SERVICE LETTER NO. SL-1

EFFECTIVITY: Rockwell Commander 112 S/N 3 through 79

SUBJECT: Rudder Assembly

Figure 1.

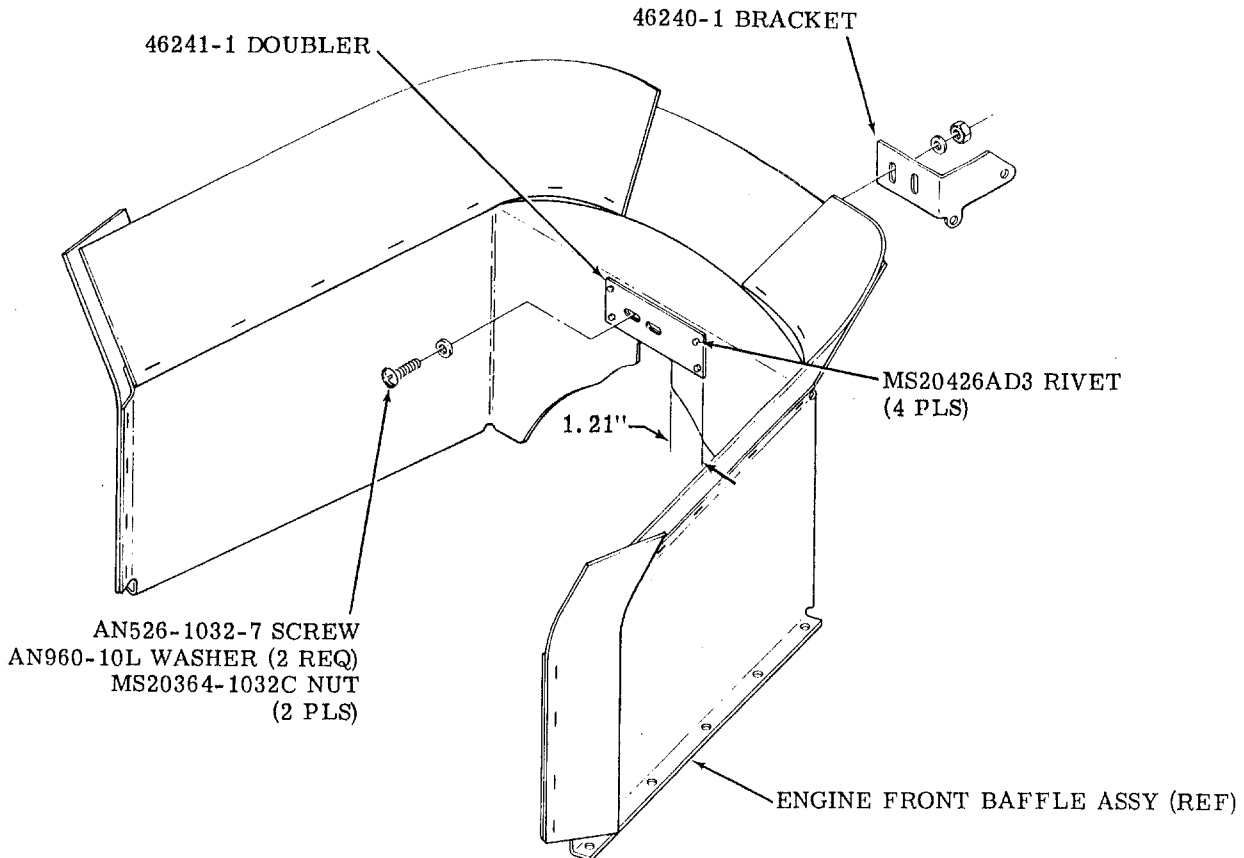
- a. Remove top engine cowling assembly.
- b. Remove and discard existing bracket from center of engine front baffle assembly (see Figure 1.).
- c. Stop drill any cracks in engine front baffle assembly using a No. 40 drill.
- d. Locate, drill and install 46241-1 doubler on engine front baffle assembly (see Figure 1.).
- e. Cut slots in engine front baffle assembly to match slots in 46241-1 doubler (see Figure 1.).
- f. Install 46240-1 bracket on engine case using existing hardware (see Figure 1.).
- g. Attach reworked engine front baffle assembly to 46240-1 bracket (see Figure 1.).
- h. Reinstall top engine cowling assembly.
- i. Proceed to AIRCRAFT RECORDS.

- a. Remove top engine cowling assembly.
- b. Remove hardware attaching existing bracket to center of engine front baffle assembly (see Figure 1.).
- c. Locate, drill and install 46241-1 doubler on engine front baffle assembly (see Figure 1.).
- d. Cut slots in engine front baffle assembly to match slots in 46241-1 doubler (see Figure 1.).
- e. Reattach engine front baffle assembly to existing bracket (see Figure 1.).

Figure 1.

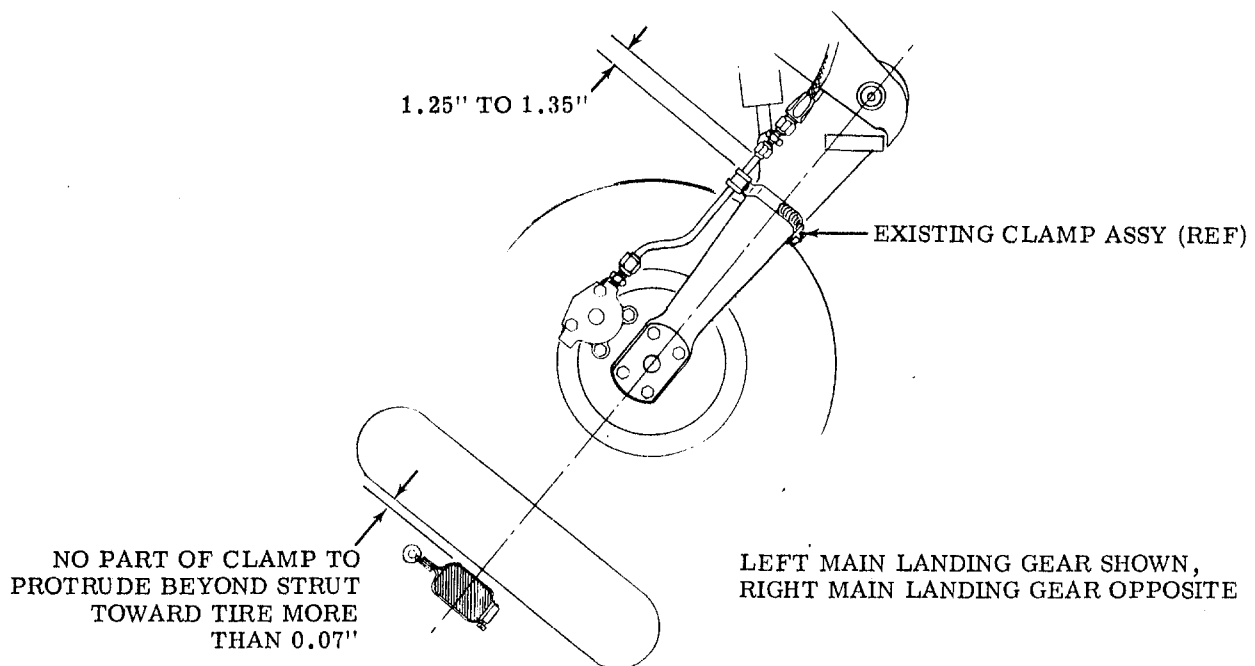
- Inspect and assure that clamp assemblies, located on main landing gear assembly, are properly installed as shown in Figure 1.
- If necessary, relocate clamps as shown in Figure 1.

Figure 1.

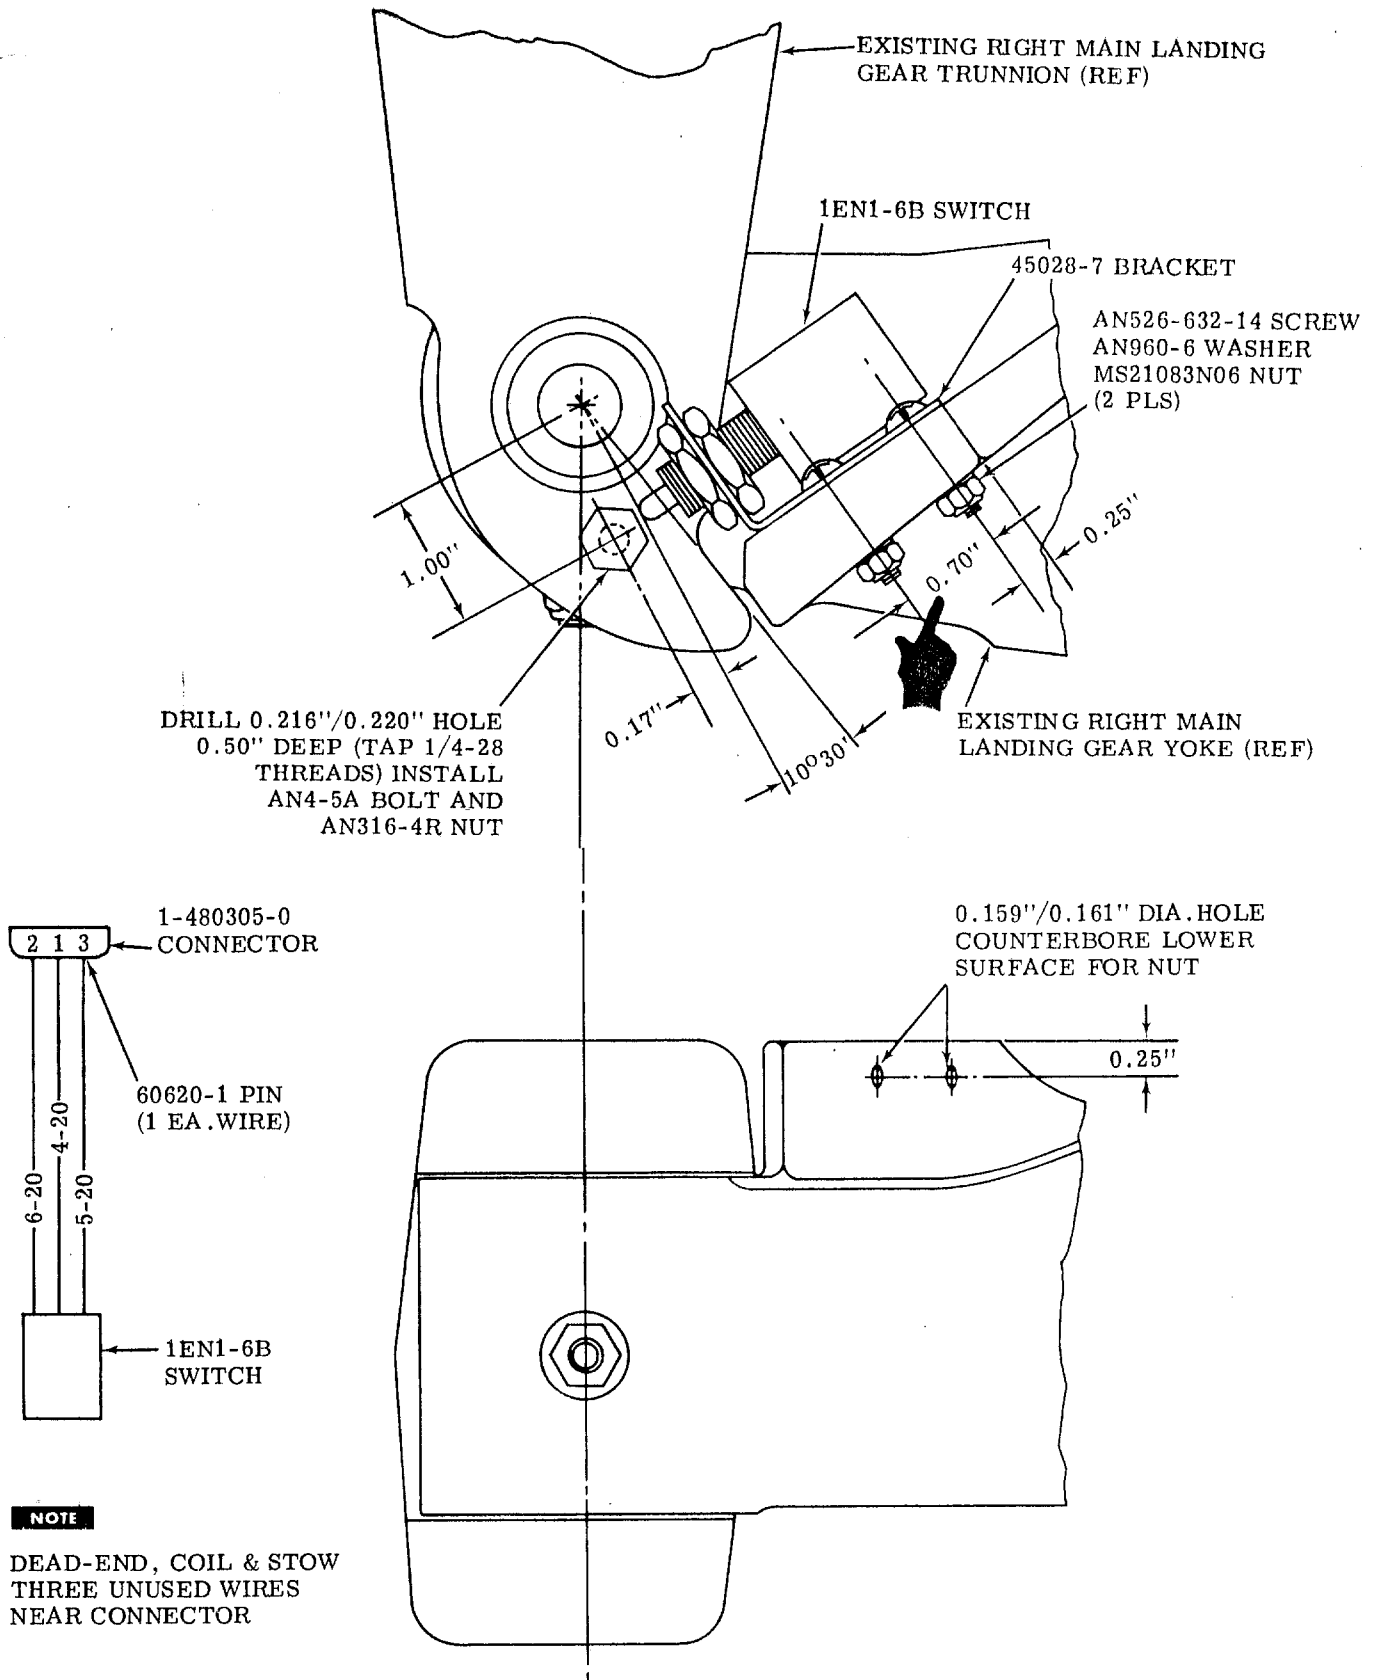
- c. Locate and drill two (2) 0.160 (\pm 0.001) inch diameter holes in right main landing gear yoke (see Figure 1.).
- d. Locate and drill a 0.218 (\pm 0.002) inch diameter hole 0.50-inch deep in right main landing gear trunnion (see Figure 1.).

- e. Tap hole drilled in step d. to 1/4-28 threads (see Figure 1.).
- f. Install and crimp 60620-1 pin (3 places) on lead wires of 1EN1-6B switch, wrap wires with SWP-1/4 spiral wrap and cover wire bundle with No.5 vinyl tubing (see Figure 1.).

- g. Press 60620-1 pins in 1-480305-0 connector (see Figure 1.).
- h. Install 45028-7 bracket and 1EN1-6B switch on right main landing gear yoke (see Figure 1.).

- j. Install AN4-5A bolt and AN316-4R check nut on right main landing gear trunnion (see Figure 1.).
- k. Adjust squat switch as follows:
 1. Place jack under right wheel.
 2. Adjust switch, by raising or lowering gear with jack, so that switch actuates within 1/4-inch of full extension of gear.

Figure 1.

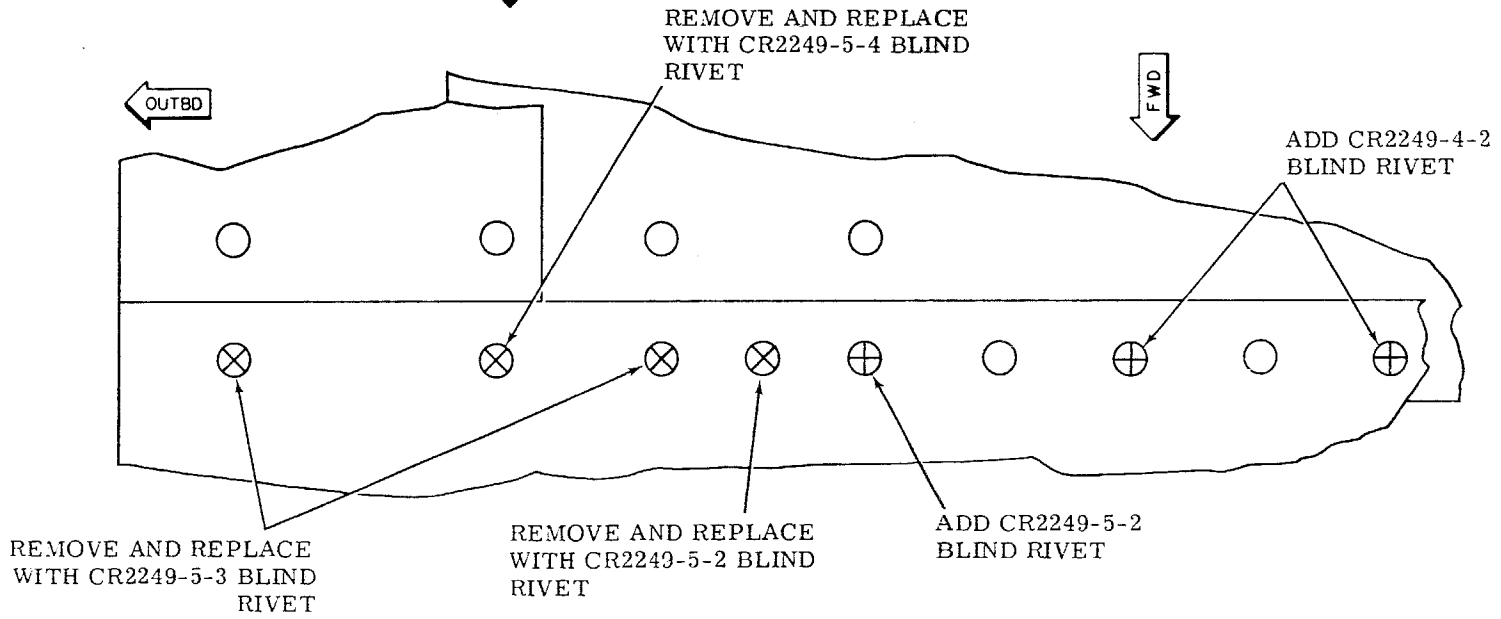
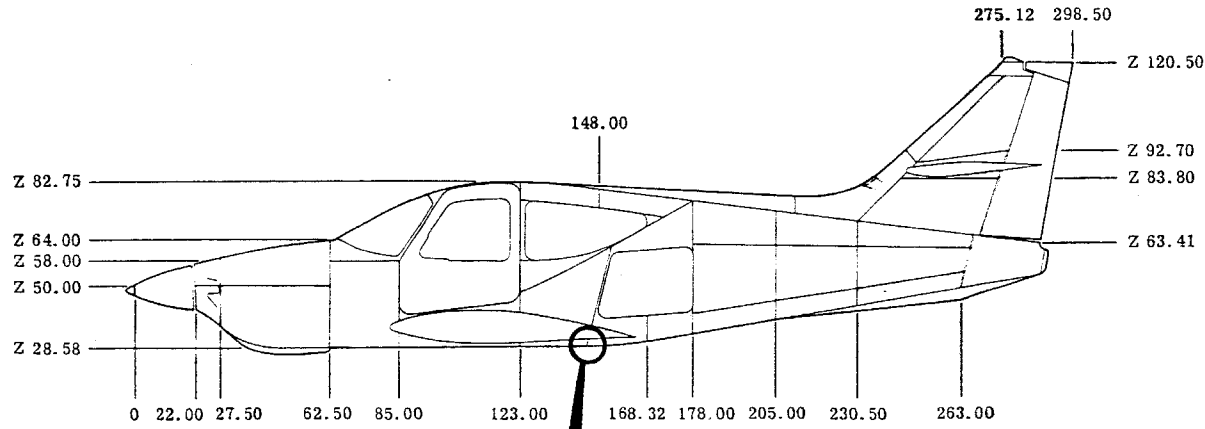
- a. Remove four (4) existing left outboard rivets from lower fuselage skin in area shown in Figure 1.
- b. Install CR2249-5-2 rivet, CR2249-5-3 rivet (2 places) and CR2249-5-4 rivet (see Figure 1.).
- c. Locate, drill and install one (1) CR2249-5-2 rivet midspaced between fourth and fifth rivet (see Figure 1.).
- d. Locate, drill and install CR2249-4-2 rivet (2 places) midspaced between fifth and sixth rivet and sixth and seventh rivet (see Figure 1.).
- e. Fill out and mail Compliance Card.

Figure 1.

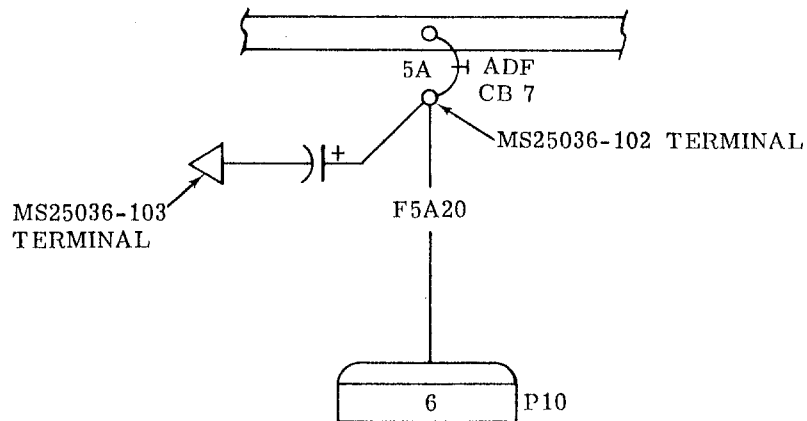
- a. Cut slots in 43025-1 bracket (see Figure 1.).
- b. Install CGS292U 050BD1 capacitor on 43025-1 bracket with two (2) MS21919DG22 clamps (see Figure 1.).
- c. Install wire leads and MS25171-1S nipple (2 pls) on CGS292U 050BD1 capacitor (see Figure 1.).
- d. Loosen nuts on left and right cabin heat control cables and right defroster control cable and install items assembled in step b. and c. and retighten nuts (see Figure 1.).
- e. Connect capacitor to aircraft electrical system as shown in Figure 1.

Figure 1.

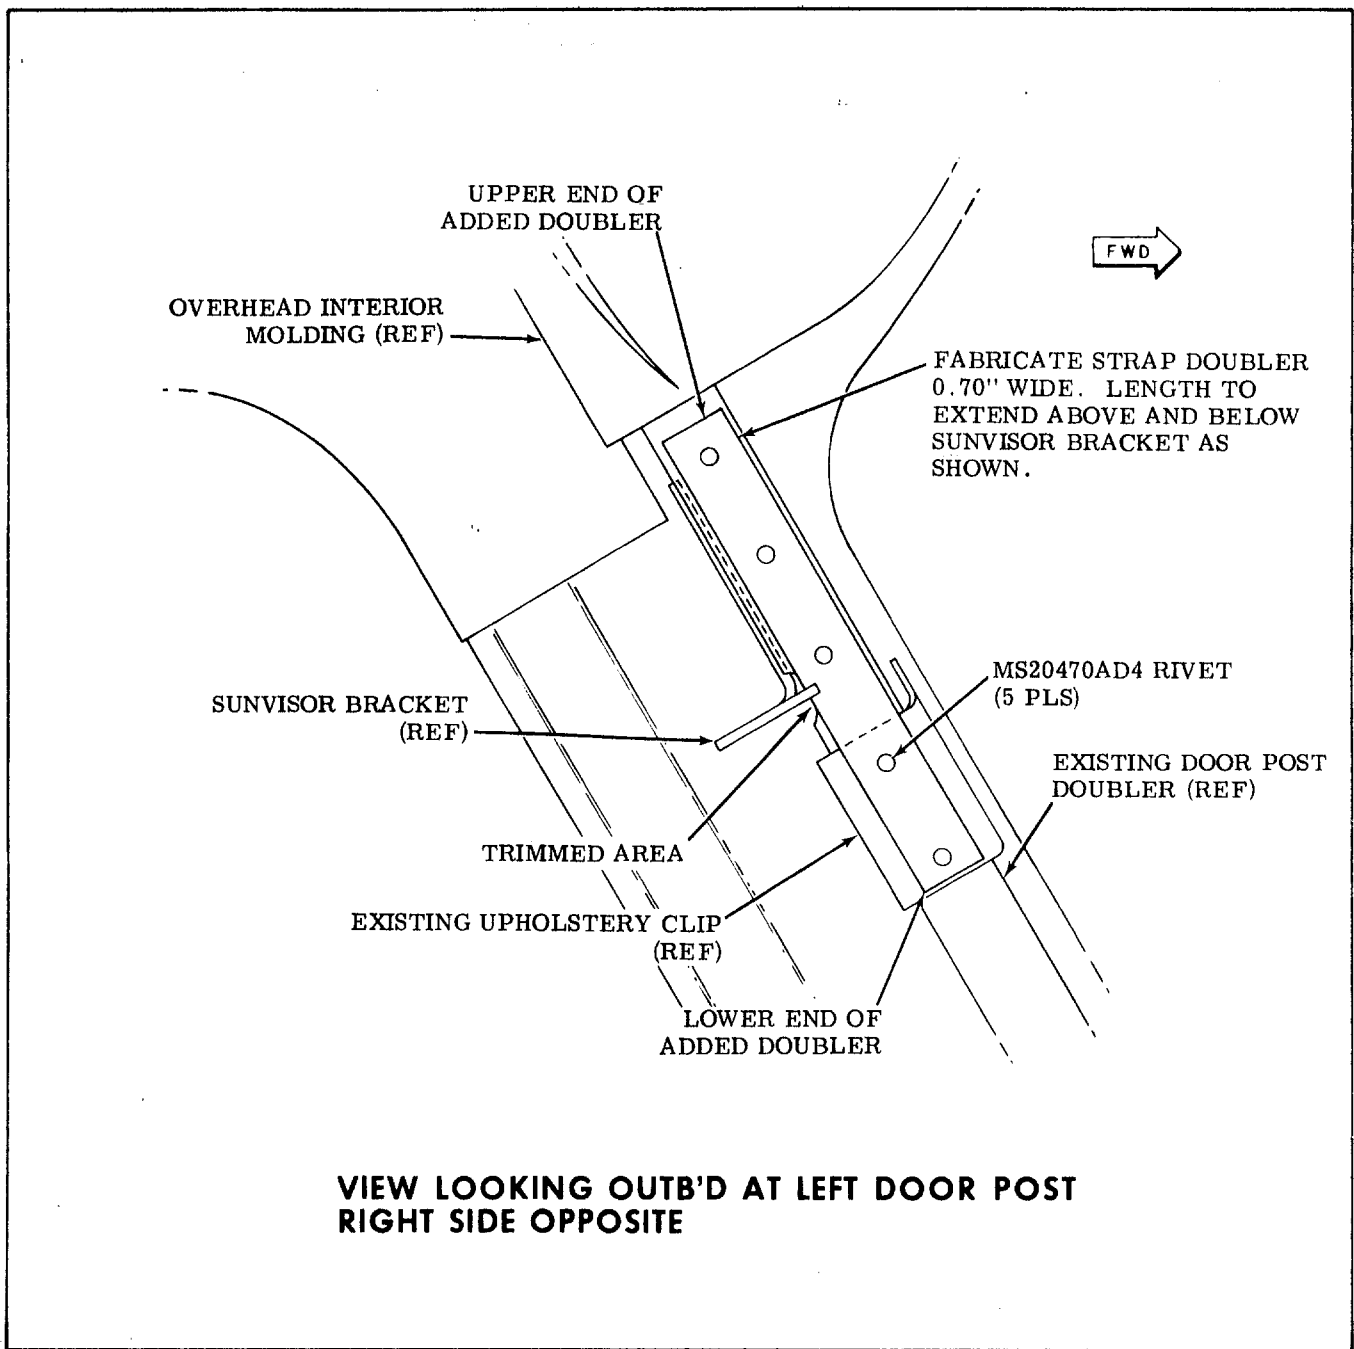
1. Remove left and right sunvisors and door post upholstery to gain access to sunvisor brackets (see Figure 1.).
2. Fabricate two (2) strap doublers, 0.70-inch wide, from 0.040 2024-T3 aluminum.

Length is shown in Figure 1. Doubler to extend two (2) rivets above and below trimmed area (around sunvisor bracket) on door post doubler picking up two (2) rivets through upholstery clip on door post.

3. Drill out existing rivets in area shown in Figure 1., and install fabricated doublers on existing left and right door post doublers using MS20470AD4 rivets.
4. Reinstall door post upholstery and sunvisors.

Figure 1.

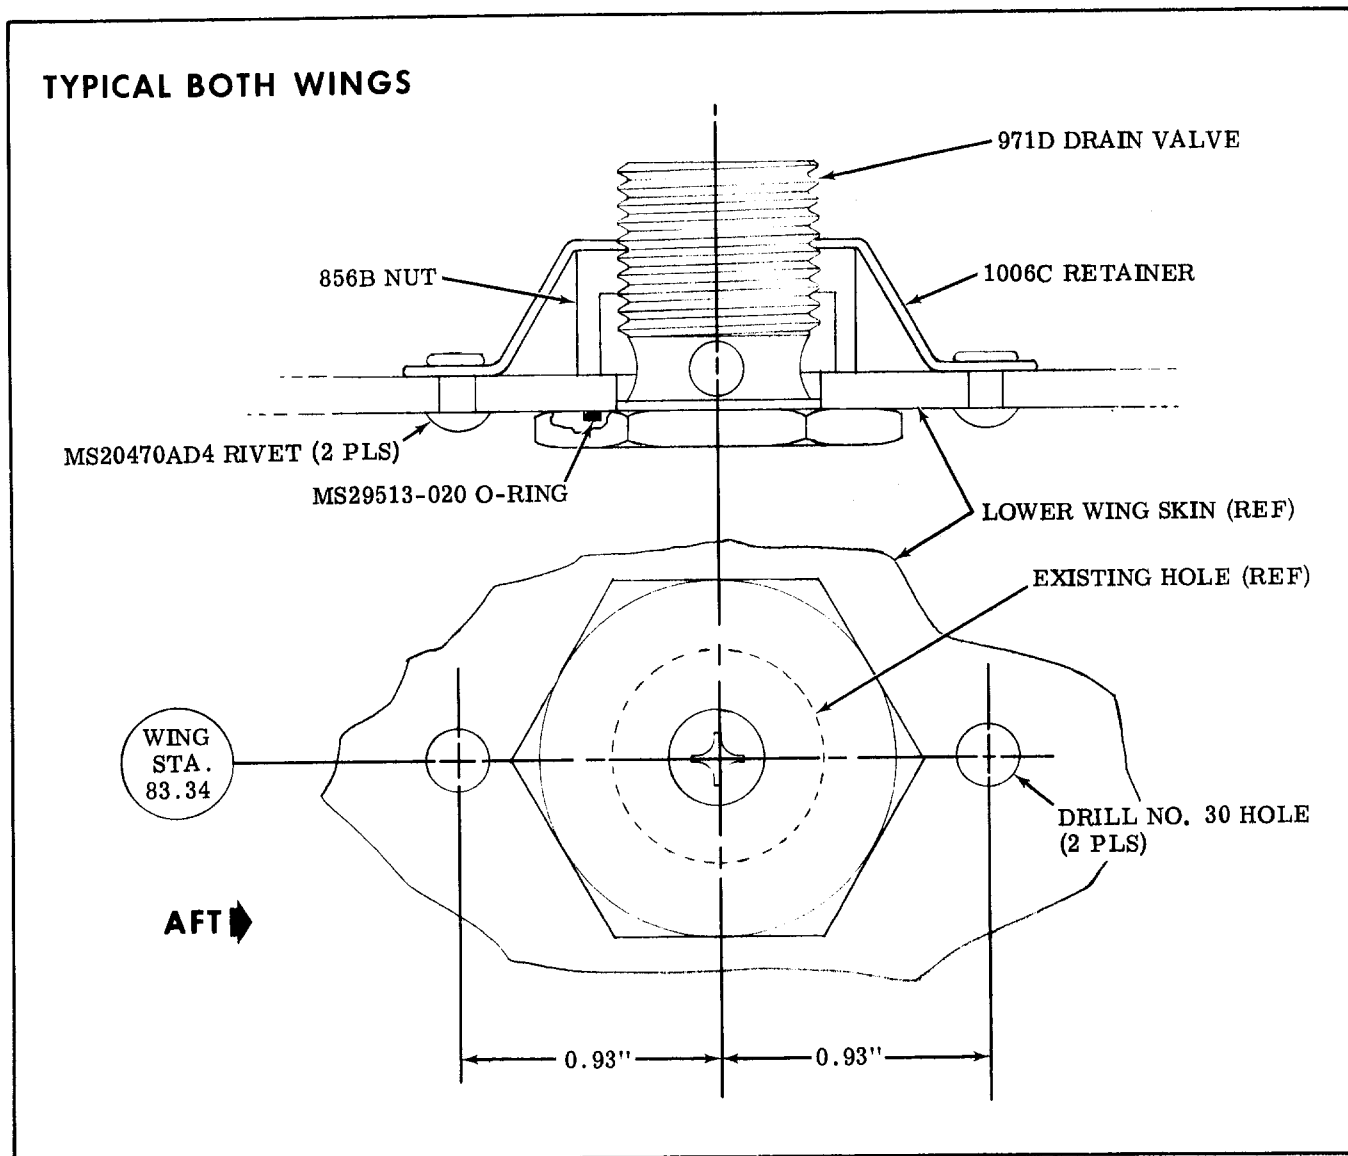
3. Remove and discard existing left and right lower wing fuel drains, located at WS 83.34.
 4. Using 1006C valve retainer as a template, locate and drill two (2) No. 30 holes in left and right lower wing skins for installation of drain valve kit (see Figure 1.).

7. Brush rivets with 1422, Class A sealant to form a fillet after installation.
8. Install 971D drain valve, MS29513-020 O-ring and 856B nut. Torque nut 480 to 690 inch-pounds (see Figure 1.).
9. Reinstall and reseal lower wing access cover(s) using PRC-1321 Class B sealant, as outlined in the Model 112 Airplane Maintenance Manual, Section V.
10. Inspect and pressure check the tanks after sealing compound has cured (approximately 8 to 10 hours) and check for possible leaks.

Figure 1.

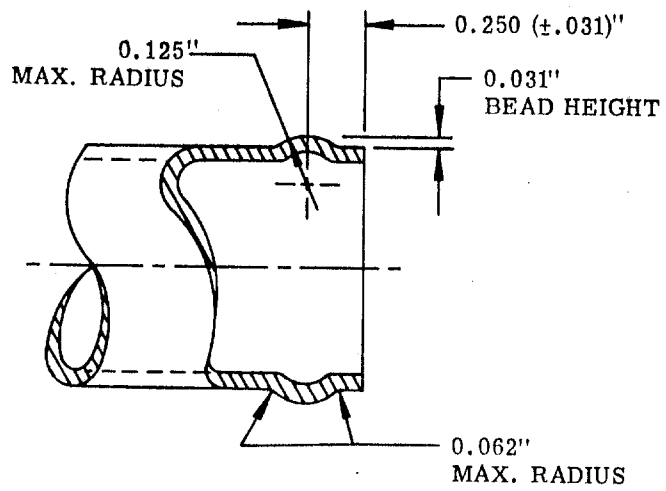
1. Remove upper engine cowling.
2. Disconnect manifold pressure gage hose from tube assembly mounted on engine.
3. Remove manifold pressure tube from engine.
4. Bead end of manifold pressure tube (see Figure 1.).
5. Reinstall modified manifold pressure tube on engine and reconnect manifold pressure gage hose using existing clamp.
6. Reinstall upper engine cowling.
